RE: 2025-T27 - Church Lane N17 s278 Works - Statutory Consultation

(New on street disabled parking bays. NB SOR= Statement of Reasons)

CYCLEWAY 1 BRUCE GROVE CHURCH LANE CONTRAFLOW

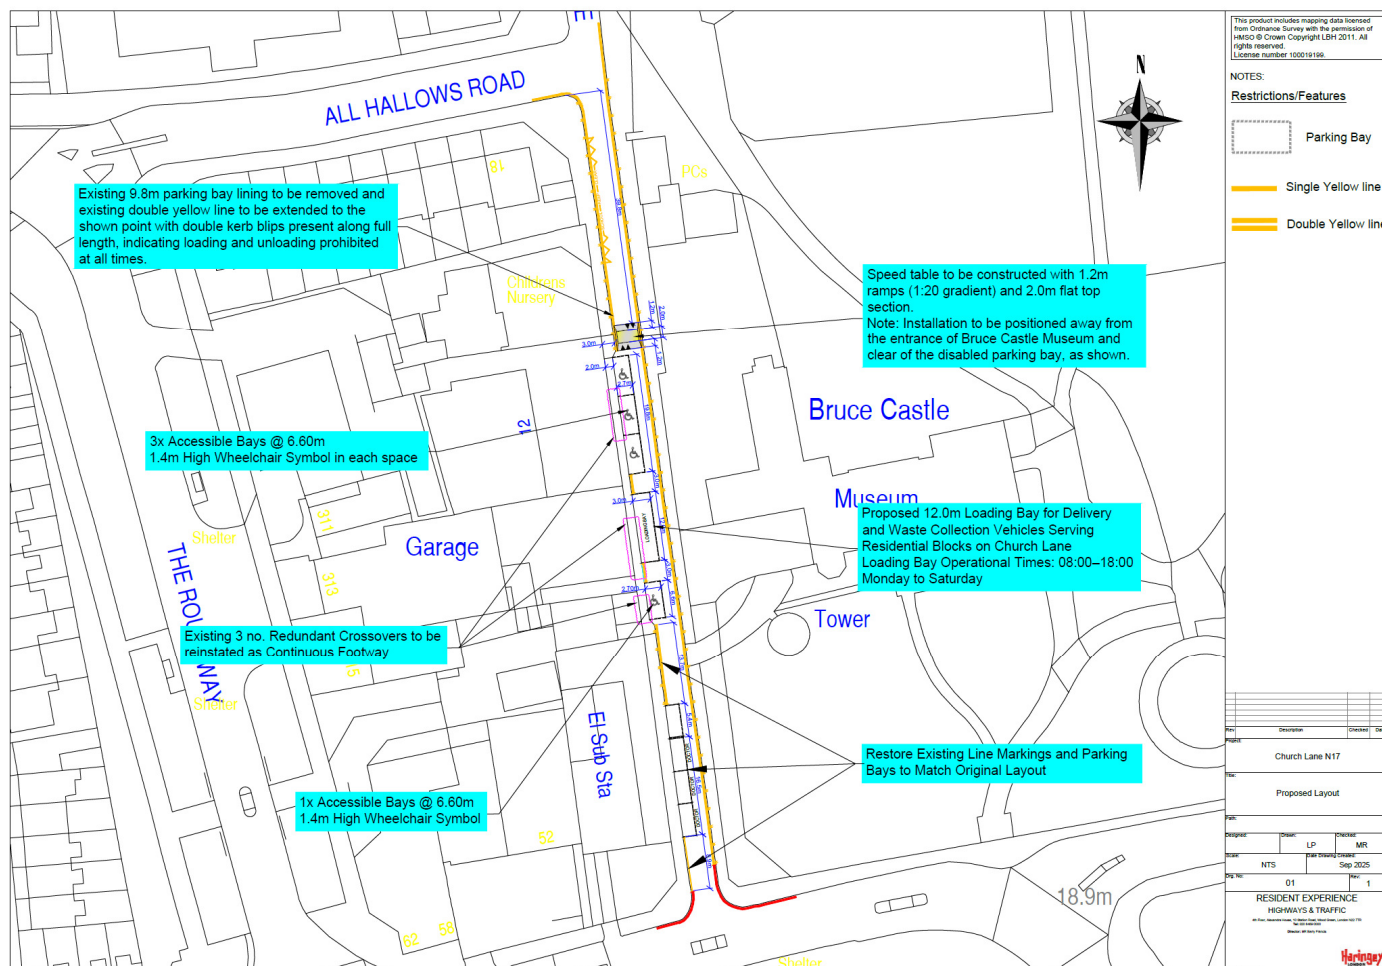
Remove parking at narrow cycle contraflow

As can be seen the car parking physically blocks the cycle route. There was recently a serious KSI at Frinton Rd, a similar contra-flow section of C1, where the victim suffered a “badly broken elbow with a mason type 3 fracture - which means the radius head is shattered”. C1 is Haringey’s primary flagship cycle route and as such should not suffer from priority being given to on-street parking.
